## CMB Meeting Minutes #148

REFERENCE Project No. M544.1, Contract No. 149 Task 1-8.02

SUBJECT: Configuration Management Board Meeting # 148 – Rev. No. 0

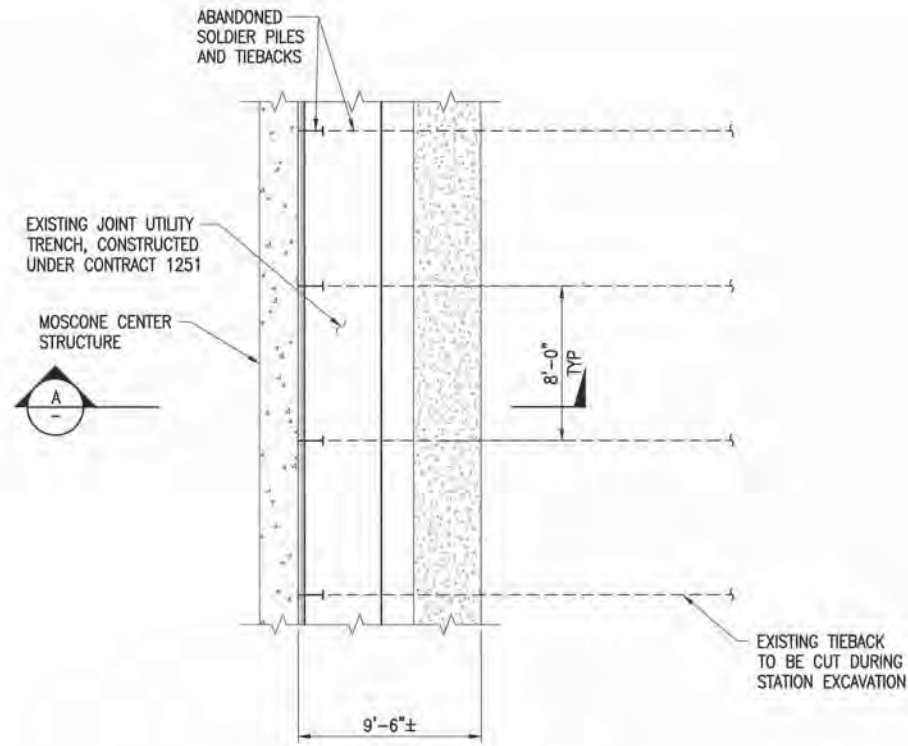
CN 1255 Drawing ES-402A shows location of inside face of slurry walls as offsets from CTL  
CN 1255 Drawing TC-111 shows offsets of centerline of tracks from CTL

CN 1252 Drawing ST-110 shows tunnel OD of 19'-8"; 1/2 tunnel DIA = 9'-10"

CN 1252 Drawing TC-xxx (recently revised) should show tunnel offset from centerline of track to be 8" instead of 6" through the extent of YBM.

Given all this, if I did the math correctly, I believe you'll arrive at the following:

NB track: theoretical clearance = 1'-4" (assuming everything built perfectly); 9" accounting for construction tolerance (4" for tunnel; ~3" for slurry wall)

\\sv6nas003\m544\1\FinalDesign\DRAWINGS\CS155-2\1255\SHEET FILES\03\_STRUCTURAL\02\_EXCAVATION AND GROUND SUPPORT\12550302ES221.dwg  
 tmarasig Mon Feb 13, 2012 4:29 pm ES-221

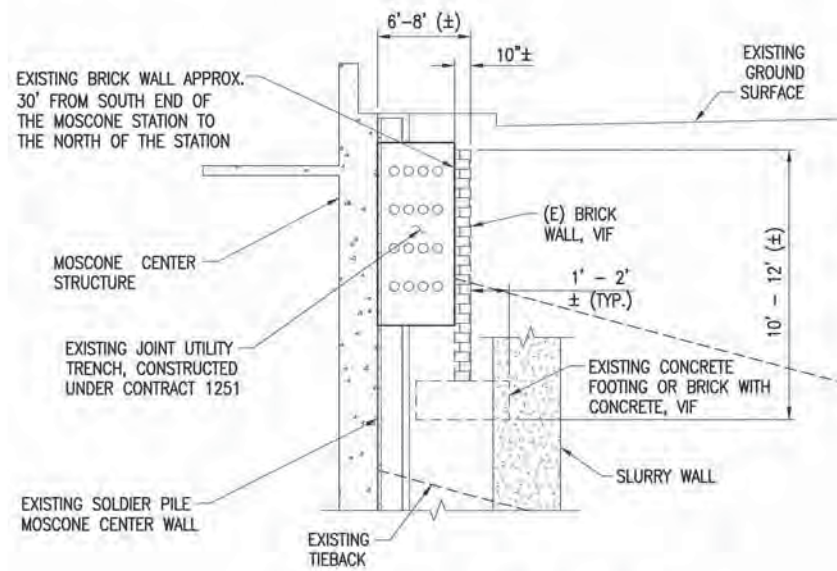
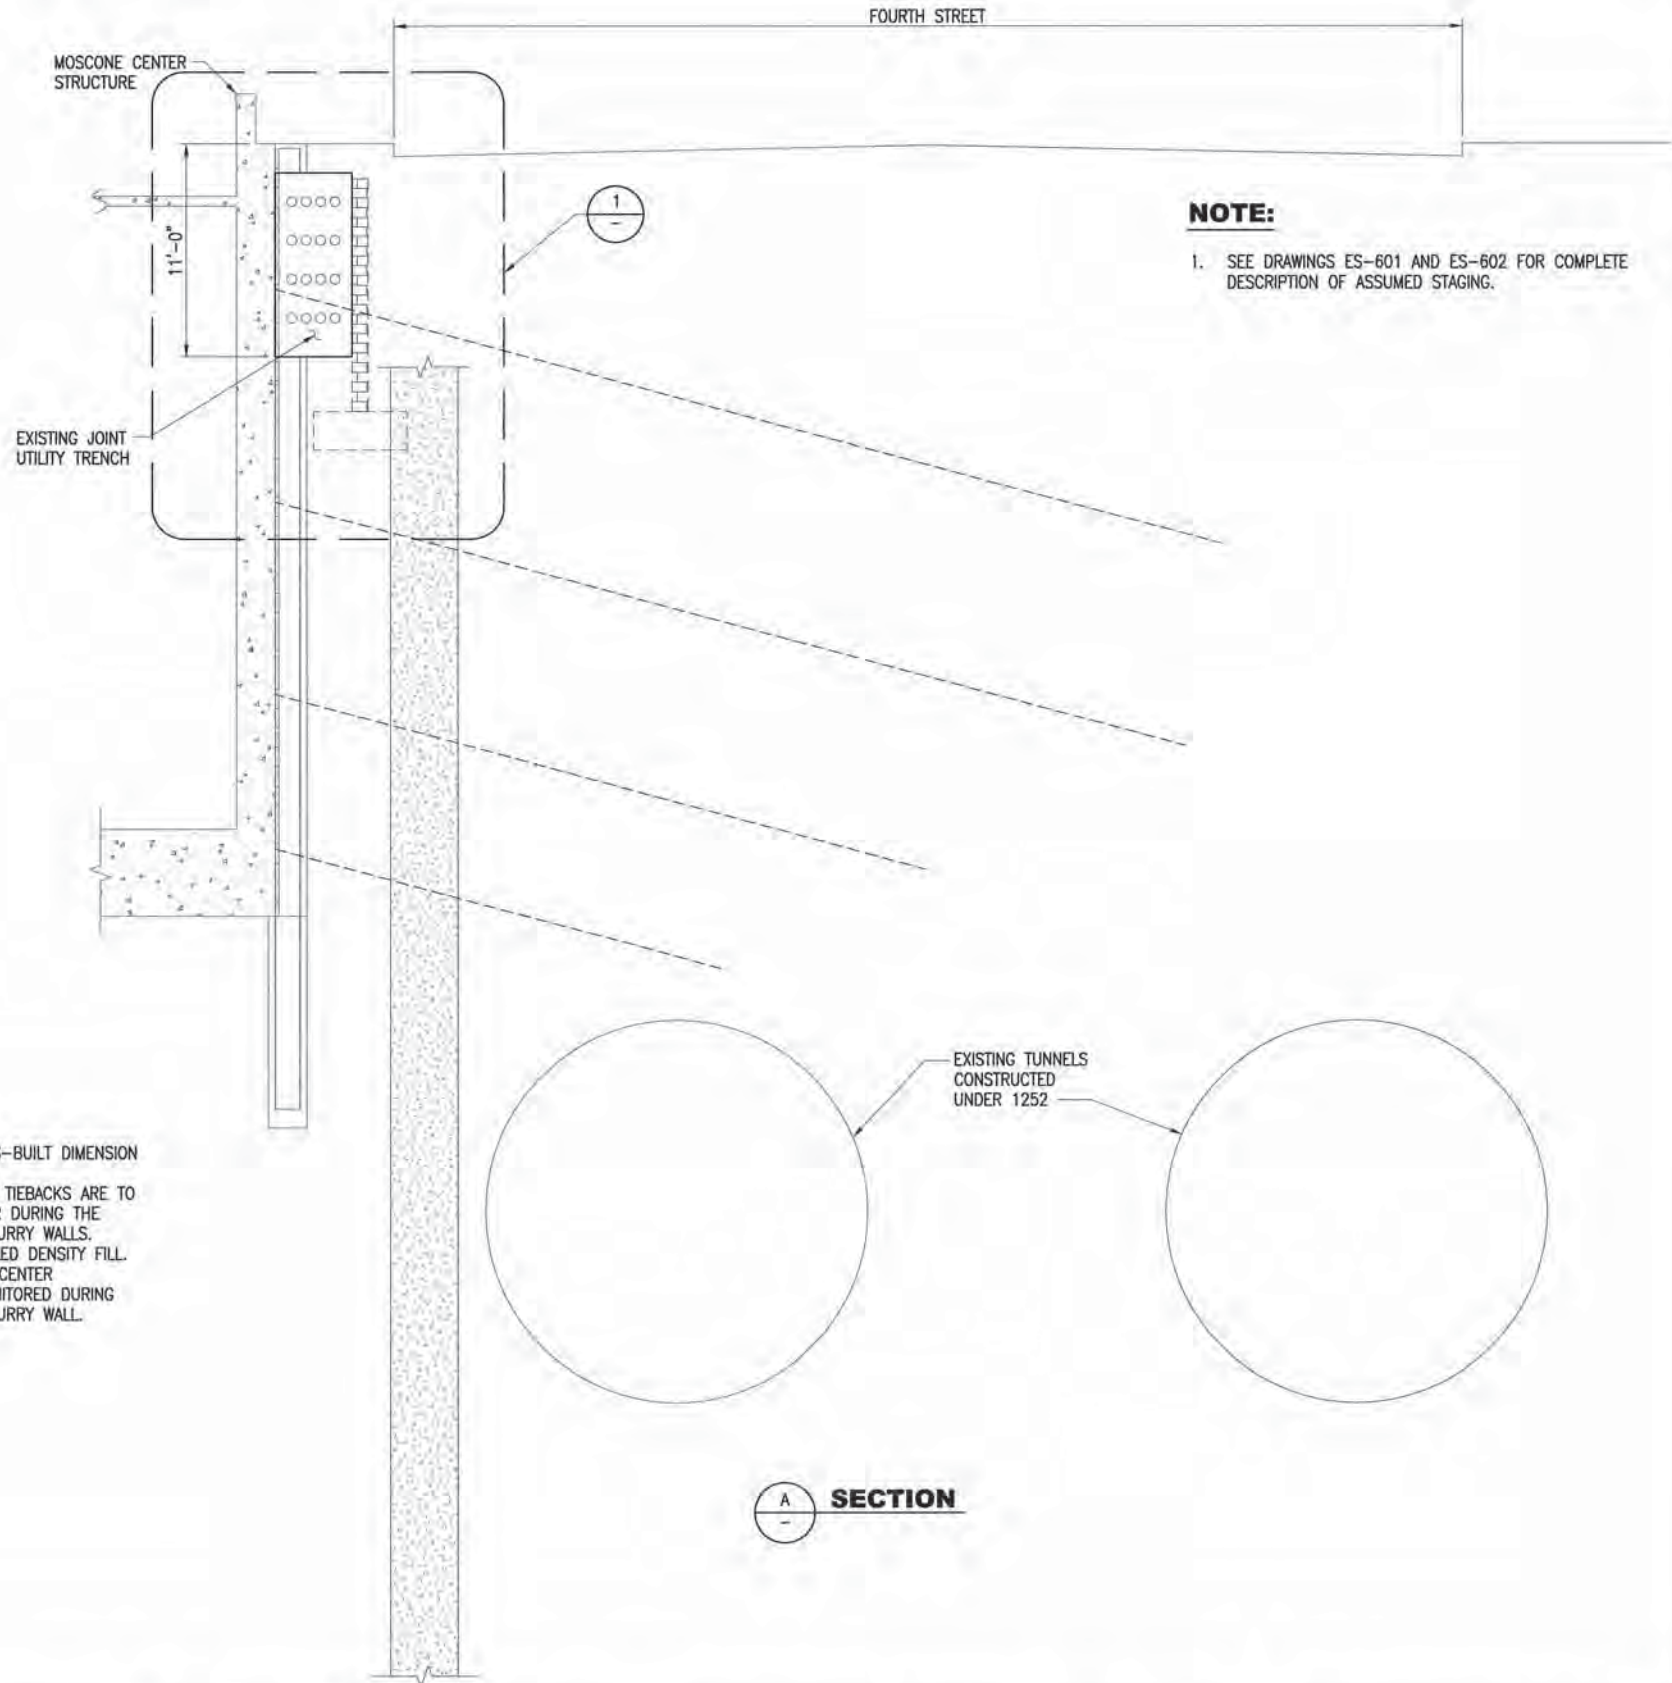
- Per Differing Site clause, it's not a DSC if a building component is in proximity to where indicated
- Synergy did " not encounter " the brick wall indicated as part of their bid , crossing 4th st per section B & C on drawing ES402 - SFMTA paid for in the bid an amount that Synergy did not encounter, this piece of wall is in proximity of where indicated on the drawings

Project: CENTRAL SUBWAY MOSCONE CENTER HEADWALLS			
Drawing: NORTH HEAD WALLS SW1 ELEVATIONS 1 & 2			
Customer: CJA/NCC JV			
Contractor: CJA/NCC JV			
Refer to Release:			
Date	Drawn	Chkd.	JOB No.
06/26/12	JW		13114177
			Dwg. No.
			MNHW-1

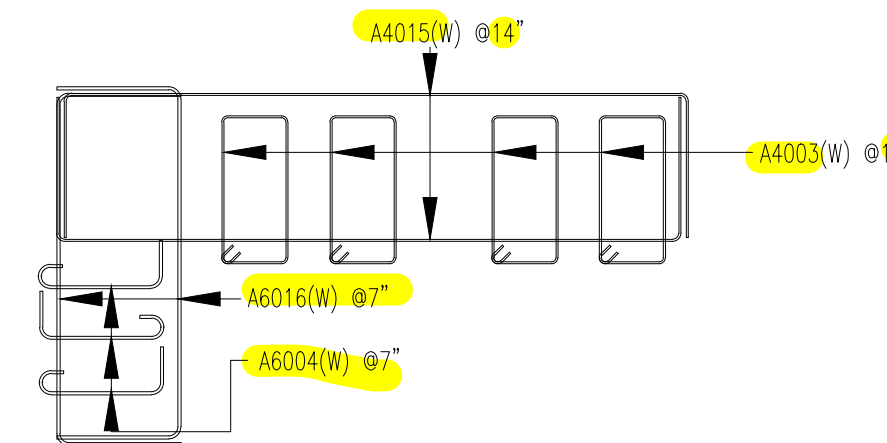
• RETURN WALL ADD VRT I.F.  
2ND LAYER  
9-A11065 (W) @6.8" ADD  
1-A11005 (W) ADD  
1-A11007 (W) ADD  
FAREST OUT FULL LENGTH

• ADD VRT I.F.  
1-#11x28'-11" (W) @13.5" ADD  
1-#11x29'-3" (W) @13.5" ADD  
1-#11x29'-8" (W) @13.5" ADD  
1-#11x30'-3" (W) @13.5" ADD  
1-#11x31'-0" (W) @13.5" ADD  
1-#11x32'-0" (W) @13.5" ADD  
1-#11x33'-1" (W) @13.5" ADD  
1-#11x35'-3" (W) @13.5" ADD  
1-#11x60'-0" (W) @13.5" ADD

• RETURN WALL ADD VRT I.F.  
4-A11062 (W) @13.5" ADD\*
